# NARRABRI GAS PROJECT

## Groundwater Management Plan

**0041-150-PLA-0015**

Date	Revision	Reason for Issue	Author	Checked	Approved
11 November 2022	0E	For approval	Eco Logical Australia / Onward Consulting	DG	TD

Figure 5.1 - Existing and Phase 1 water production forecast

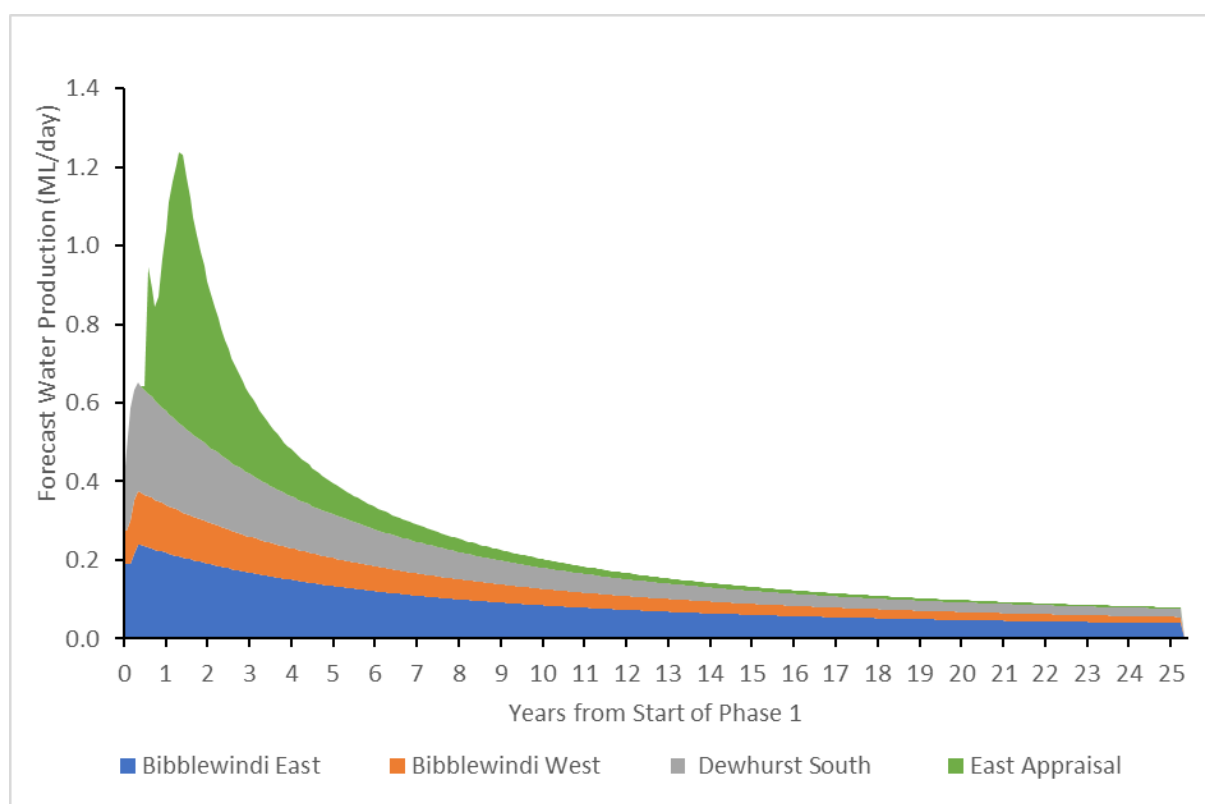
16	4.4.4	Natural methane leaks and accumulations		<b>[Randall Cox]</b> First para – should 'WBR' be 'GBR'	The correction has been made and the rest of the document checked for similar errors.
17	5.1	Groundwater extraction		<b>[Jack Warnock]</b> On page 30 of this Plan there is Figure 5.1 Existing and Phase 1 water production forecast. This Figure has been presented elsewhere. The time frame for Phase 1 is from Year 0 to Year 10. However, on page 6 of the Groundwater Modelling Plan, Figure 3.1 represents a timeframe for Phase 1 from Year 0 to Year 25. Should there be more clarity in the timeframe for Phase 1 of the Project?	The text in section 5.1 has been amended as follows: <i>The model used to determine the potential groundwater impact from the Phase 1 operation was conservatively based on a 25-year operational life for the Phase 1 wells.</i>  Figure 5.1 has been replaced with Figure 3.1 from the GModP.

18	5.1	Groundwater extraction	The predicted take of water from coal seams for Phase 1 of the NGP is shown in Figure 5.1.	<b>[Randall Cox]</b> The text and the figure label refer to water forecast for Phase 1. More correctly the data is total water forecast from wells constructed during Phase 1, over the full life of those wells.	Text in Section 5.1 has been amended as follows: <i>The predicted total water take from wells constructed prior to Phase 1 of the NGP, over the full gas production life of those wells, is shown in Figure 5.1</i>
19	5.3	Subsidence		<b>[Randall Cox]</b> The section first refers to the EIS predictions about minimal impact. The section then goes on to reference the Appendix B study, which is about monitoring not some geomechanical study leading to prediction. Suggest the reference to the Appendix B study be contained to Chapter 4 and be deleted from Section 5.3. Otherwise, there will be a tendency to think the Appendix B study contains something about prediction.	The last 3 paragraphs in section 5.3 have been moved to section 4.3. Section 4.3 established existing conditions of the site, including background subsidence – presented in detail in Appendix B.

Figure 8.1 - Monitoring points against which trigger levels have been applied

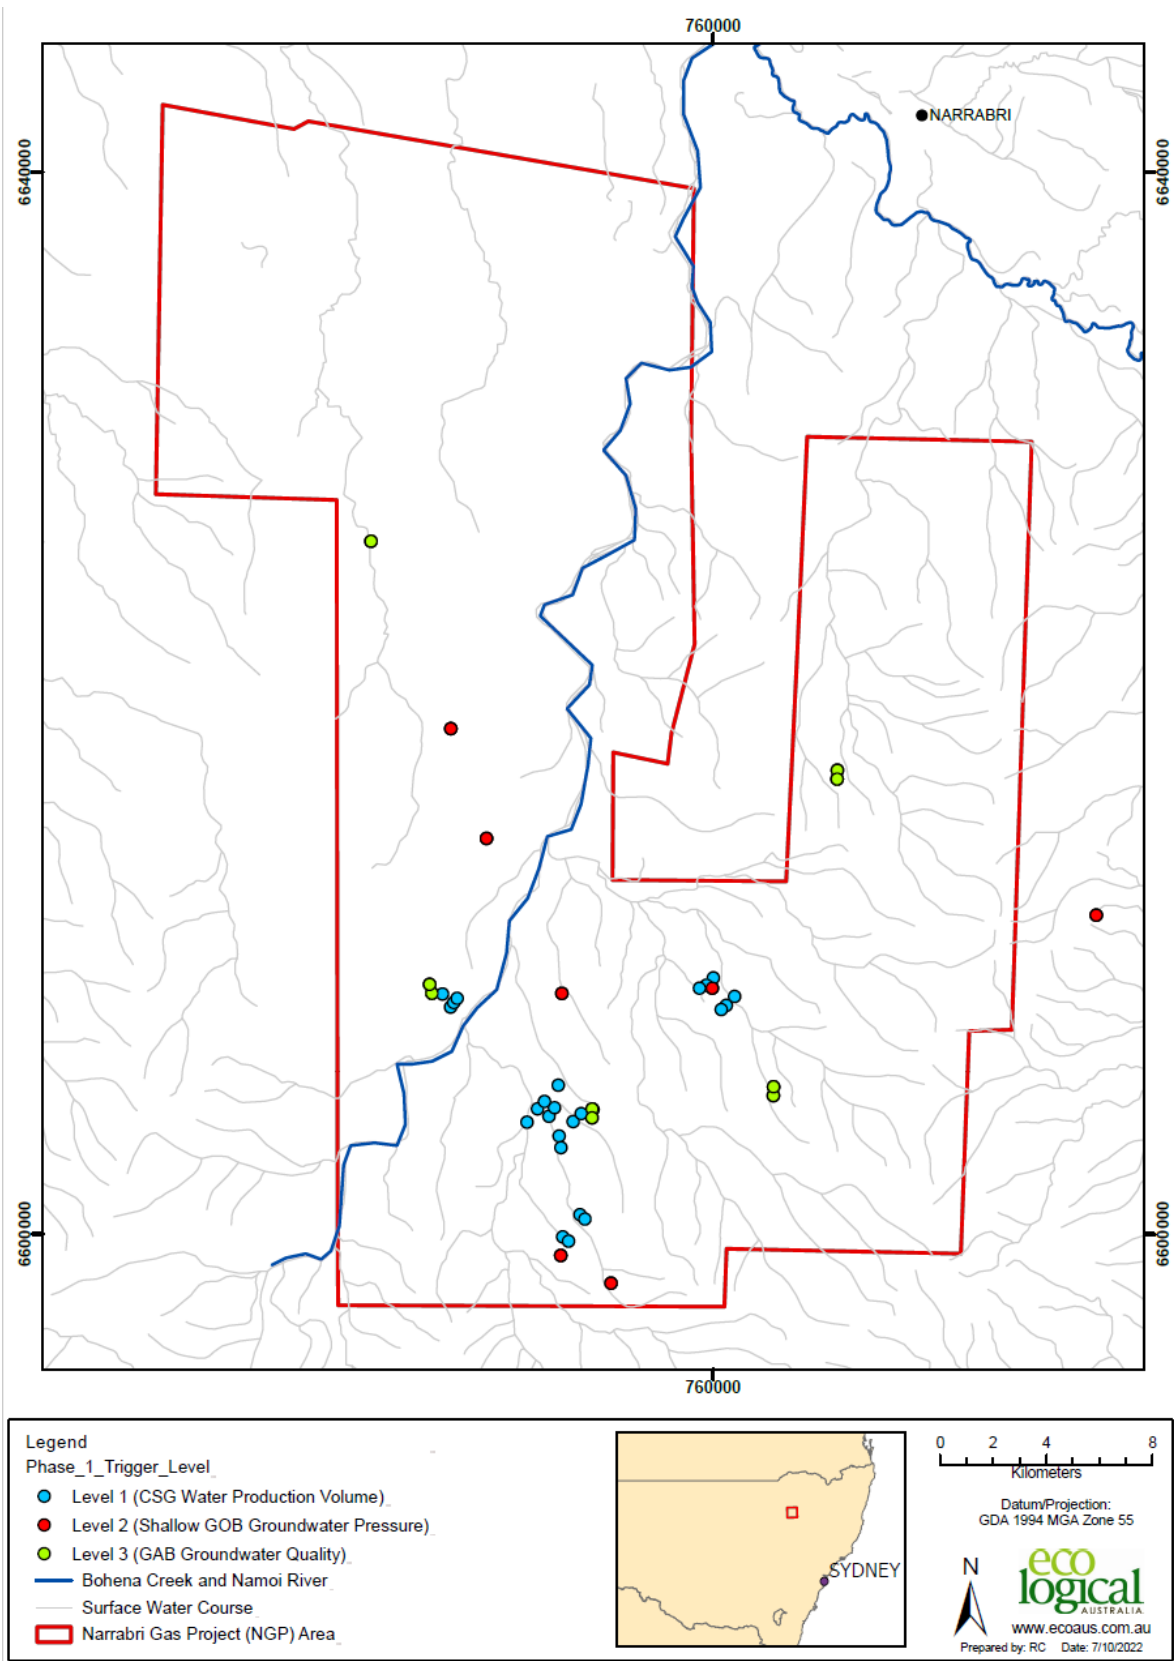
35	8.4.2	Level 2 trigger		<b>[Randall Cox]</b> Second bottom para p44. Refers to site ‘BHNS1’. Figure 8.1 shows the location of site ‘BHN1S’ One of the references must be incorrect	The correction has been made. The well reference should be BHN1S.
36	8.4.2	Level 2 trigger		<b>[Jack Warnock]</b> On page 44 second last paragraph. Should Sites “BHNS1” actually be “BHN1S”?	Refer to comment above.
37	8.5	Trigger response		<b>[Randall Cox]</b> Second para refers to ‘GMonP’ – should it be ‘GModP’	The correction has been made.

**Figure 2.1 - Baseline monitoring locations in Alluvial Groundwater Sources**

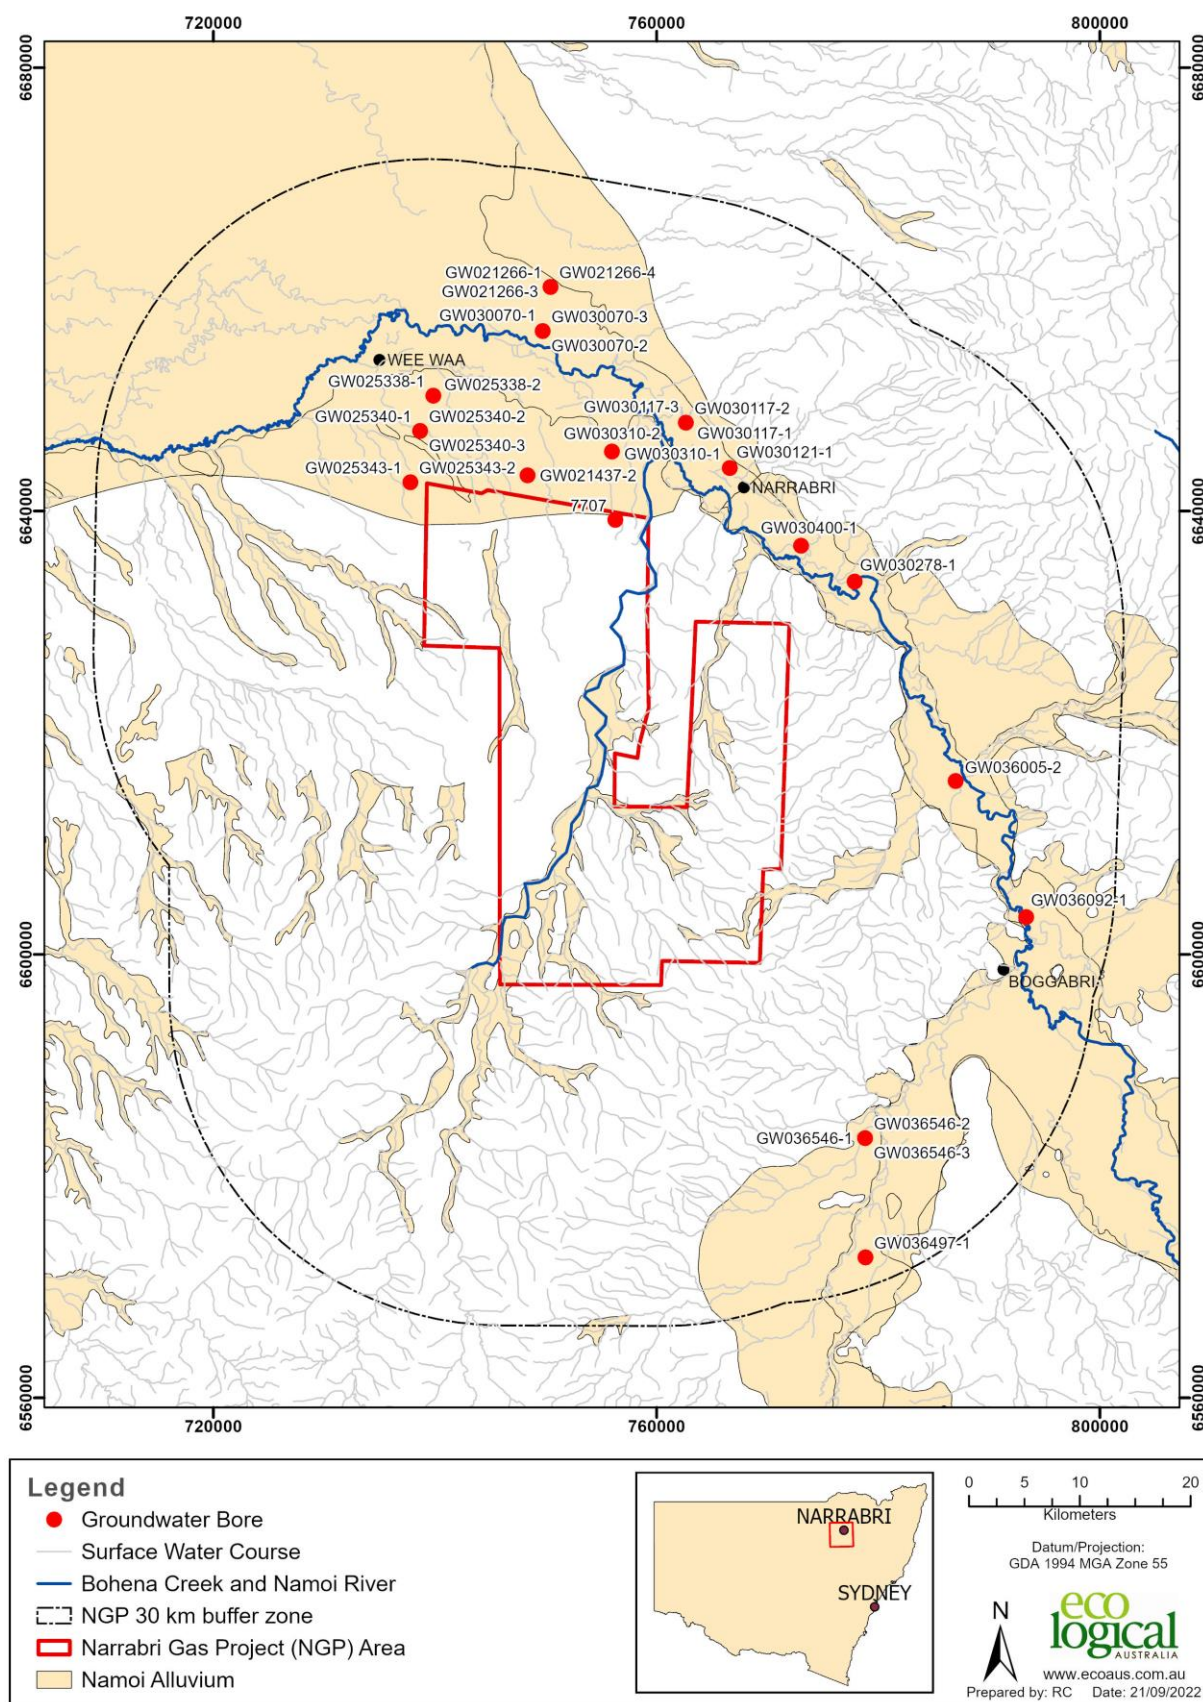
11	2.1	Private landholder bores	Figure 2.1 - Baseline monitoring locations in Alluvial Groundwater Sources	<b>[Michael Williams]</b> It is difficult to conceptualise the Narrabri Gas Project having a measurable impact on the Upper Namoi or Cox's Creek alluvium.	Noted. No response required.
12	2.1	Private landholder bores	Figures 2.1 to 2.3	<b>[Michael Williams]</b> While the figures are correct, it is confusing as the terms that govern the geographic distribution are being mixed. Section 1 are water sources and section 2 are hydrostratigraphic units. It would be clearer if the Figure titles in Section 2 removed the term "groundwater sources".	Tables 2.1 and 2.2. link the hydrostratigraphic units described in Section 2 to the Water sources described in Section1 and the titles of Figures 2.1 to 2.3. Table headings have been changed to reflect this.
13	3 Appendix A	Groundwater baseline data – pressure and levels		<b>[Randall Cox]</b> I had a difficulty relating the plots in Appendix A to the text in section 3. It would help if Appendix A was structured into geologic units to match the way Table 3.1 is structured.	The plots in Appendix A provide the same data as that in Table 3.1, with Table 3.1 structured into geologic units to assist interpretation. The sequence of the plots in Appendix A has been amended to follow the structure of Table 3.1.

Figure 3.1 - Phase 1 annual water production forecast

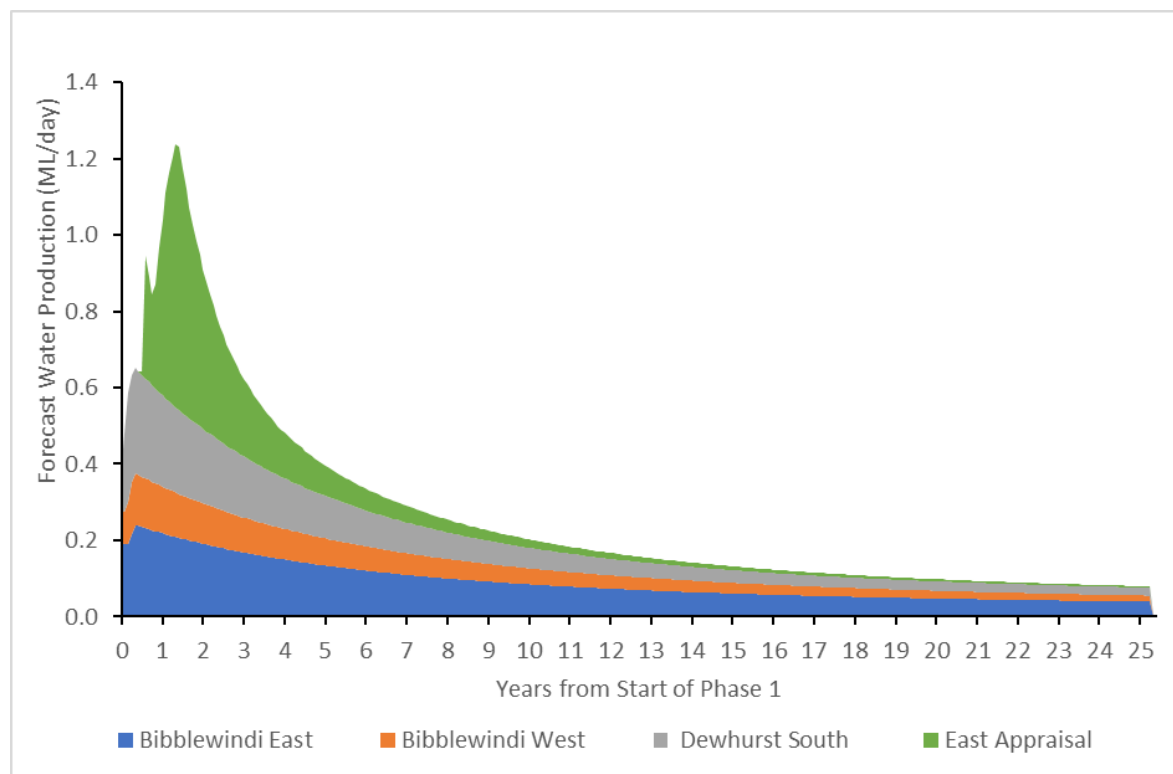
8	3.2	Phase 1 method statement	No specific text reference.	<b>[Jack Warnock]</b> As referenced elsewhere, the dates represented in Figure 3.1 Phase 1 annual water production forecast refer to 0 to 25 years from start of Phase 1, whereas other references are made to 0 to 10 years for Phase 1. Could the period of time for Phase 1 be clarified?	In line with the revised text in section 5.1 of the GMP, the text in section 3.2 has been amended as follows: <i>The model used to determine the potential groundwater impact from the Phase 1 operation was conservatively based on a 25-year operational life for the Phase 1 wells.</i> The Model was updated with the Phase 1 annual water production forecast as shown in Figure 3.1. The forecasted water production is 2.9 gigalitres (GL) over the a period of 25 year period with an expected production peak up to 1.26 megalitres (ML) per day (ML/day) approximately two years from the start of Phase 1.
